APPLICATION FOR EXCHANGE OF WATER

61-349 / Exchange # 79609

Re: Water Right Exchanges (#79609, 79610, 79611, 79612), Additional Information Request

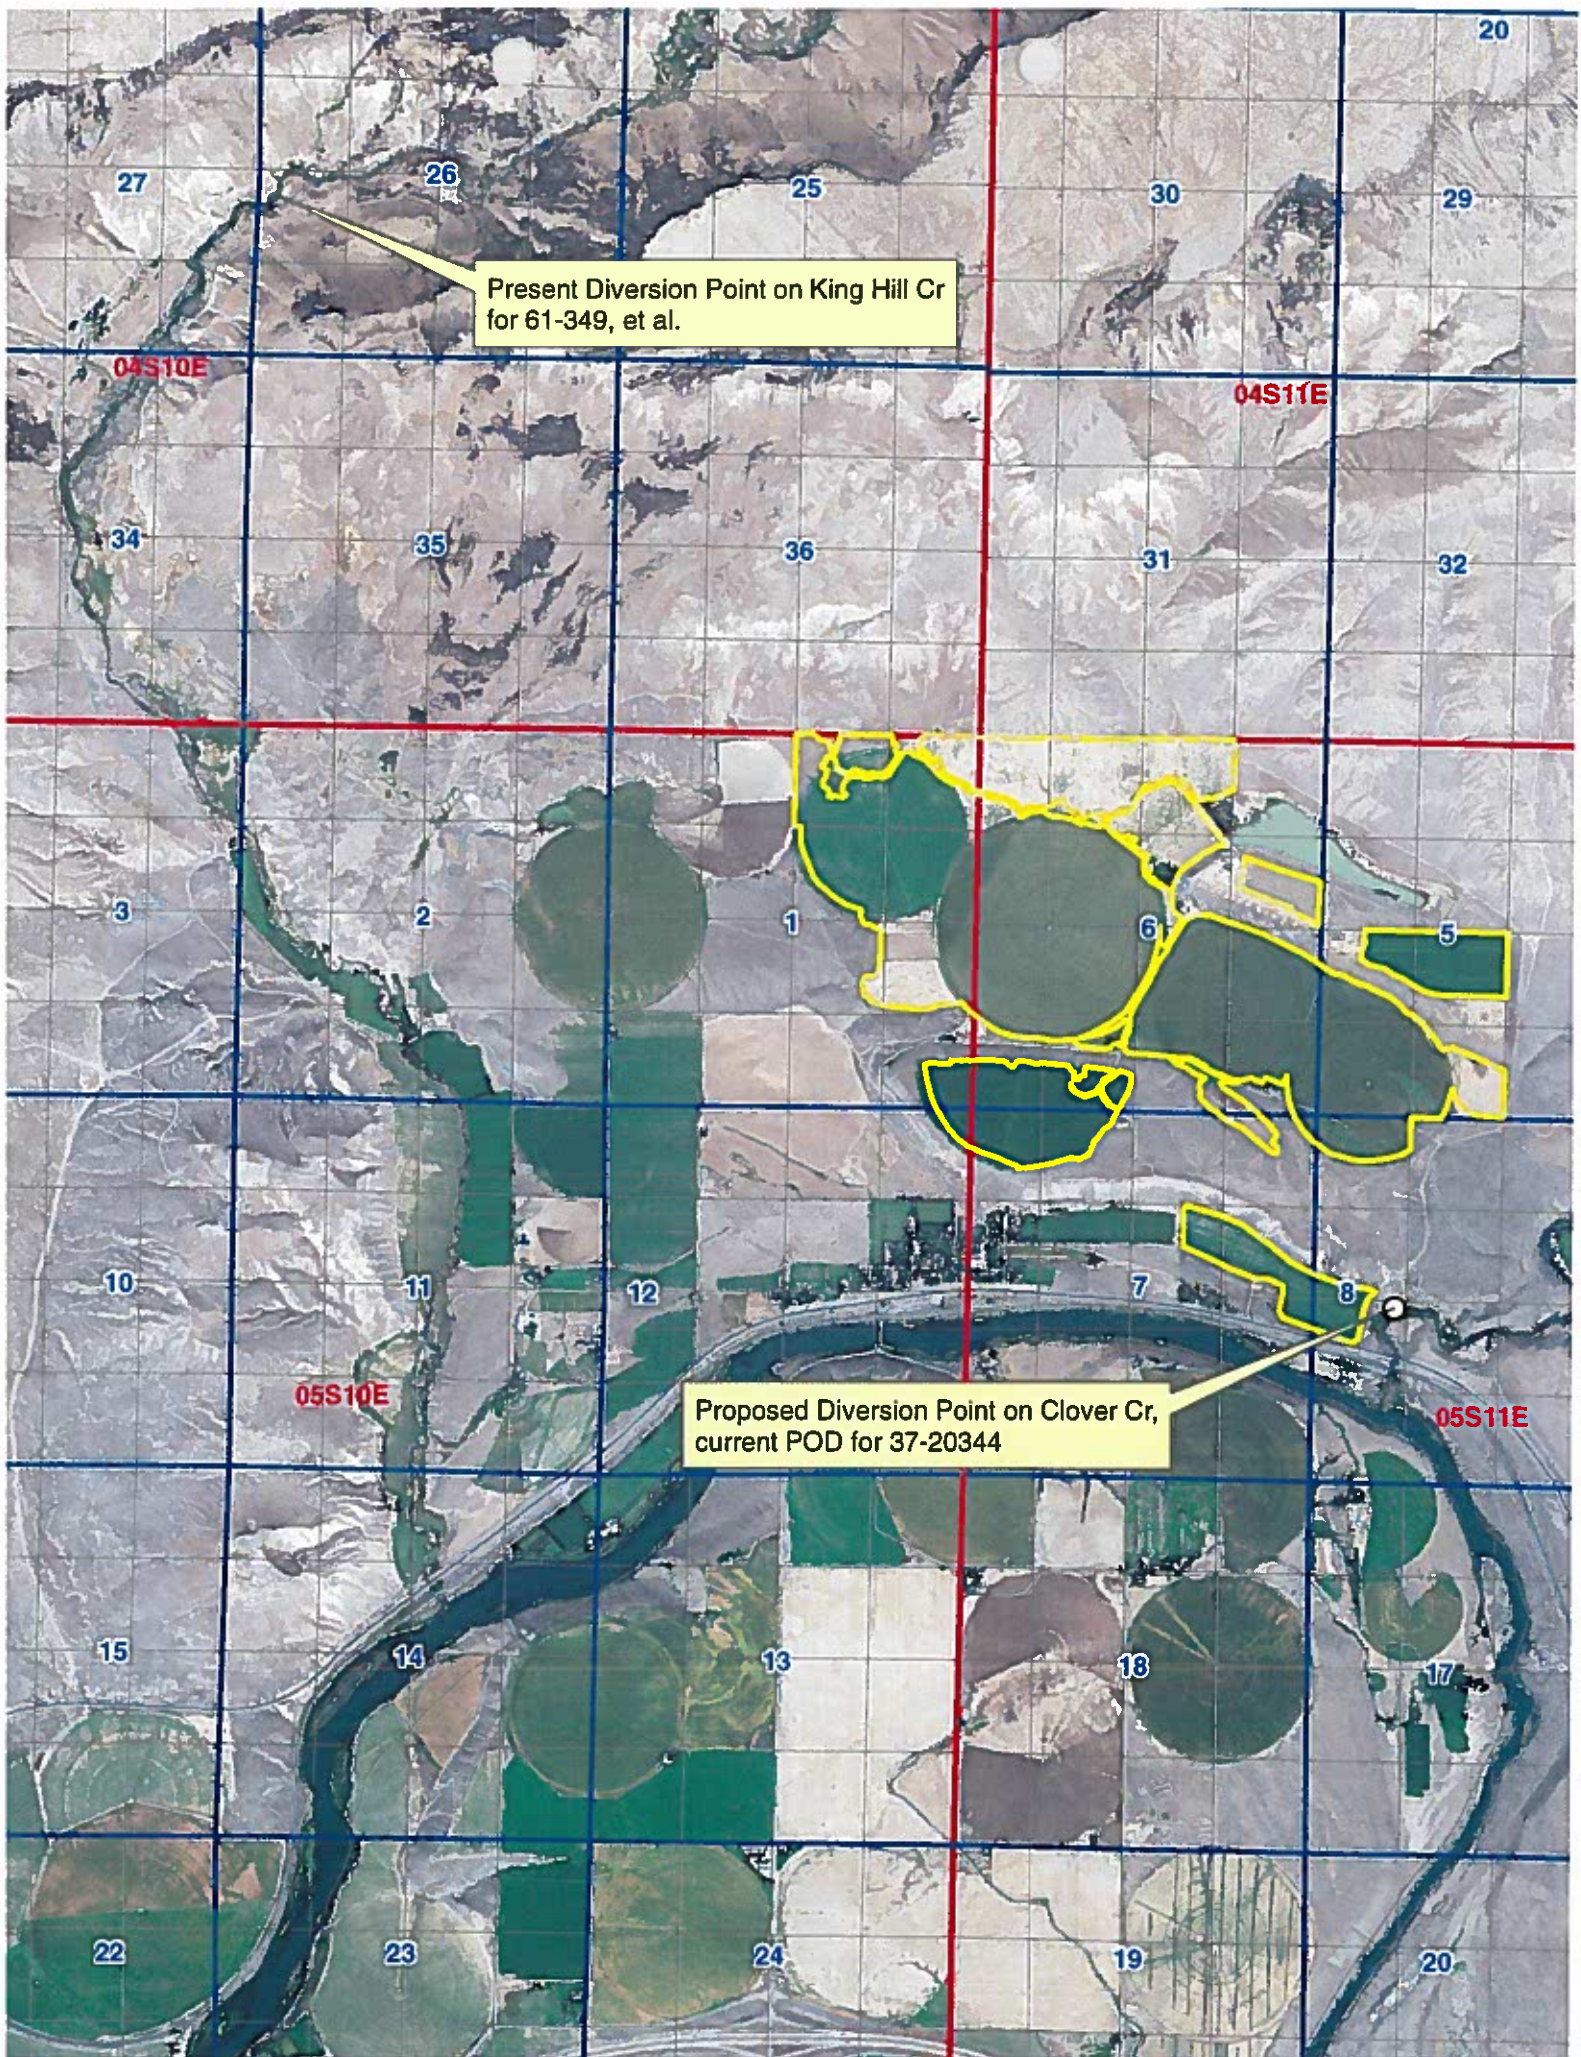
Pitchfork Ranch has proposed exchanges for 4 water rights diverted from King Hill Cr (rts 61-349, etc). The proposal is to then divert the rights from Clover Cr in Basin 37 at a point that already exists. The attached map portrays the circumstances.

There are some junior rights downstream from the present Pitchfork Ranch diversions. King Hill Cr has historically been a watermaster district, 61F, do either one of you know if it is active and, if so, then who would I be in touch with?

Corbin, as Basin 02 water Master, do you perceive of potential injury and/or recommend conditions? It would appear that a condition would be needed to limit diversion from Clover Cr to those priorities and flow rates that water is available from King Hill Cr. However, if there is no watermaster then how could it be regulated? Would Pitchfork need to measure water discharged to the Snake River from King Hill Cr (or at least measure below the junior downstream diversion) and limit exchange to that rate of flow? Do we have a capability to have Pitchfork self report flow rates and diversions? If the proposal is not administrable, then can/should we approve it?

If we are going to approve it then Southern Region is contemplating making the rights subordinate to all rights in Clover Cr. However, there isn't a watermaster on Clover Cr so we are back to the regulatory question.
